Ingersoll Equipment Co., Inc.

SERVICE BULLETIN

85-1

SUBJECT: Traction Drive System: Model 108, 110, 116 Lawn Tractors

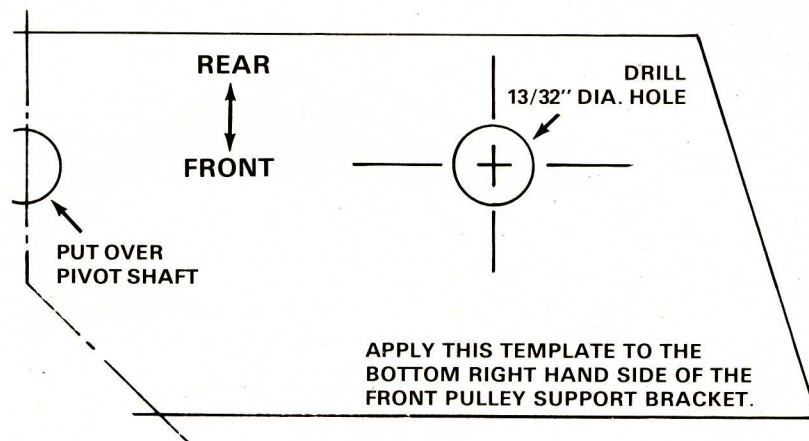
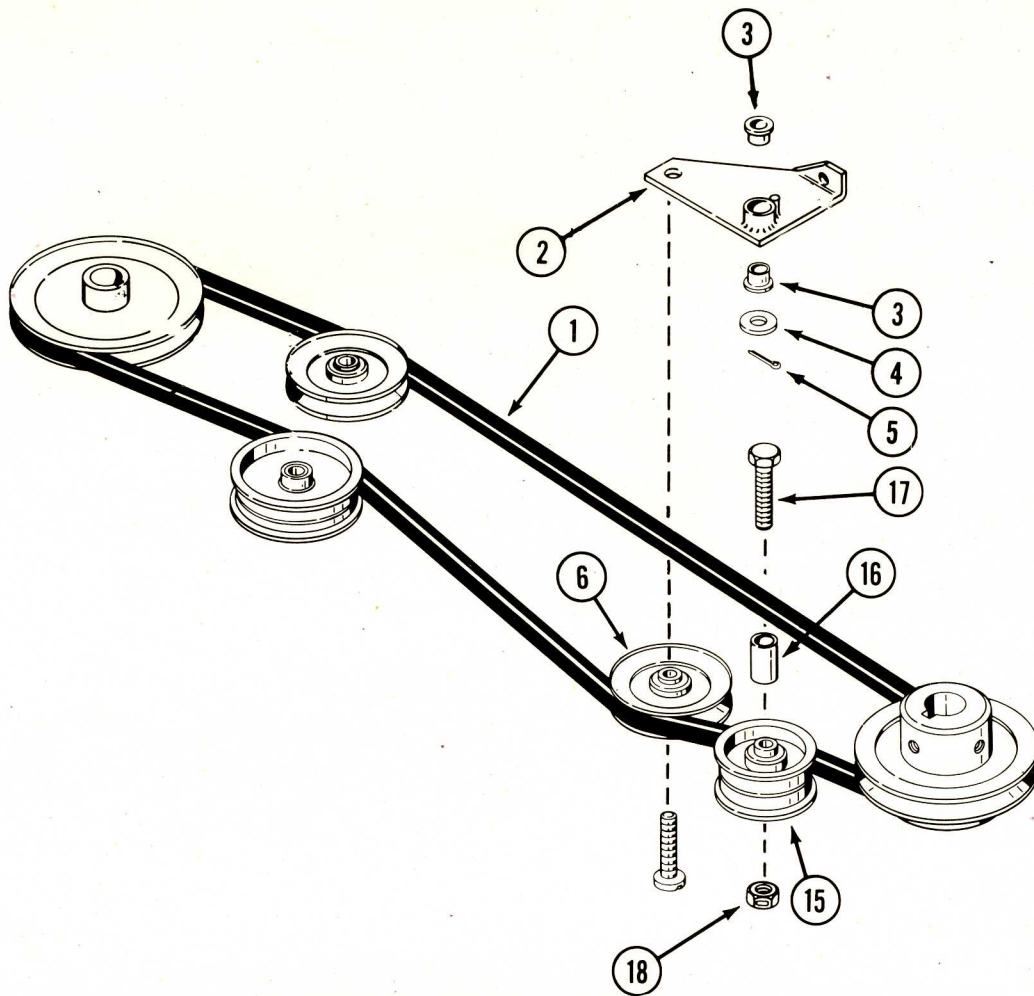
1. To insure proper belt life by preventing contact between the main drive belt and cotter pin (5) as described in "1" above.
2. To insure that proper clutching and shifting characteristics are maintained.
3. To relocate backside idler pulley (15) if necessary to achieve 1 and 2 above.

1. Remove the mower deck if installed
2. Remove backside idler pulley (15) and bolt (17).
 - a. Loosen the two left hand engine mounting bolts.
 - b. Remove the two right hand engine mounting bolts.
 - c. Remove nut (18) and pulley (15).
 - d. Tilt the engine and remove bolt (17).
 - e. Replace and retighten the engine mounting bolts.
3. Apply the template provided with these instructions to the front pulley support bracket.
4. Center punch and drill a new 13/32" dia. hole where indicated on the template.
5. Install pulley (15) with bolt (17) in the new hole. INSERT THE BOLT FROM THE BOTTOM UP.
6. Install the belt. Check for proper clutching action and traction. Adjust the belt, by moving the rear idler pulley, if required, as described in the operator's manual.

FIGURE 1

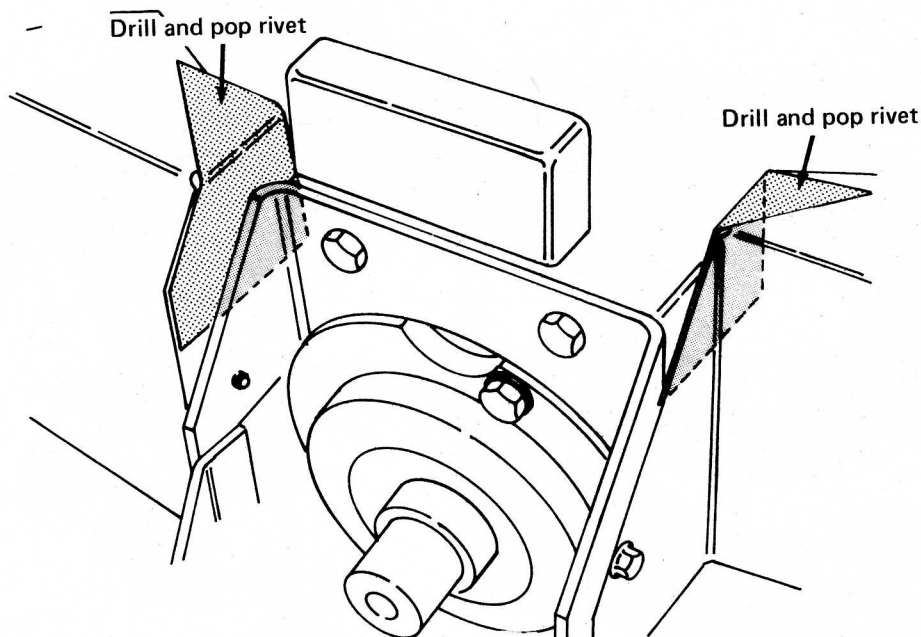
- a. Raise the fuel level in the carburetor float bowl by turning over the float helper spring in the carburetor.
- b. Reduce heat at the carburetor by installing 2 baffle extensions on the rear cylinder baffles.
- c. Keep the fuel supply cooler by installing insulation on the fuel line.

2. Loosen (Do Not remove) the screws which secure the rear cylinder baffles to the pump mounting bracket.
3. Slip the rear cylinder baffle extensions in position. Make certain the corners are closed off. See Figure 1. Tighten the screws.
4. Drill through the rear cylinder baffles and baffle extensions and pop rivet together.

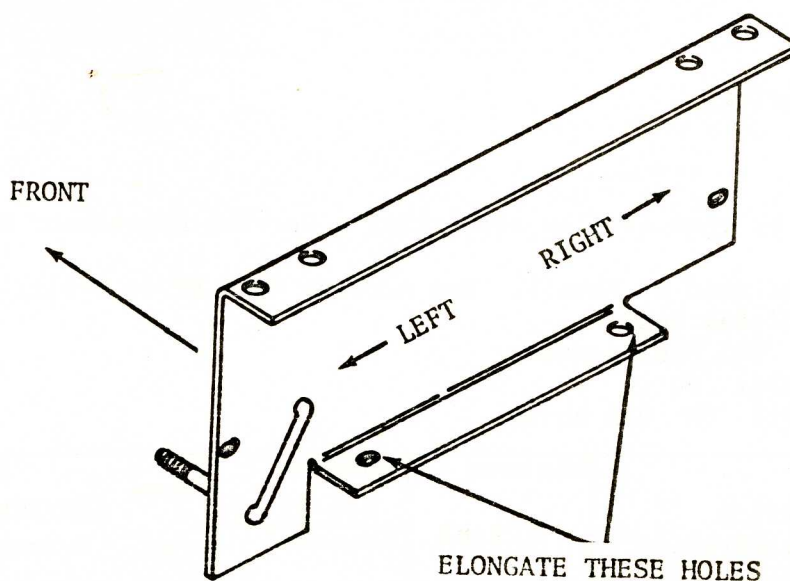
Each dealer must elongate the mounting holes in the front seat support on affected units. Only partial high range gear engagement is possible on affected units. This causes premature wear and failure of the gear teeth. Moving the front seat support slightly to the left will allow the shift lever to hold full engagement.

1. Remove the fenders and rear seat support.
2. Carefully push the fuel tank aside and remove the front seat support with the seat attached.
3. Clamp the front seat support in a vice.
4. Elongate the front seat support mounting holes 5/16" (8 mm) to the RIGHT. This will allow the seat support to be shifted to the left. (Right and left are determined as seated in the tractor seat facing forward.)
5. Install the front seat support (with seat) and shift it as far to the left as the elongated holes will allow.
6. Tighten the bolts.
7. Check for full high range gear engagement.

Push the lever "down" into high range as far as it will go and release it. The distance between the top edge of the lever and the bottom edge of the pin must not be more than .12 inch (3.2 mm). If the distance exceeds .12 inch (3.2 mm), remove the seat support and increase the slot size.

INSTALLATION INSTRUCTIONS
P/N C26589 REINFORCEMENT KIT FOR J-22/K-22 SLEEVE HITCH
(SEE OTHER SIDE FOR C26592 KIT)

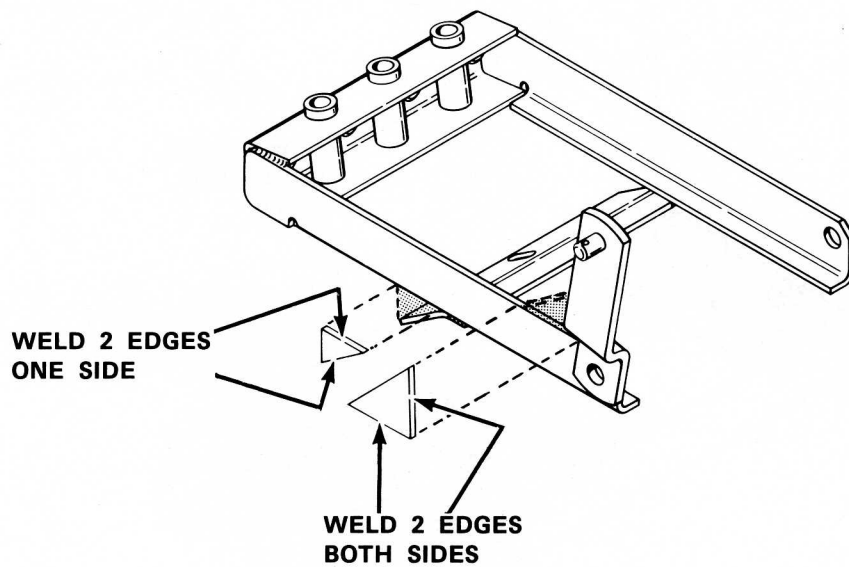
Each dealer must reinforce the sleeve hitch in accordance with the attached instructions if installing a Model J-74 End Drive Tiller.

Weld reinforcements to the sleeve hitch frame as shown in the illustration.
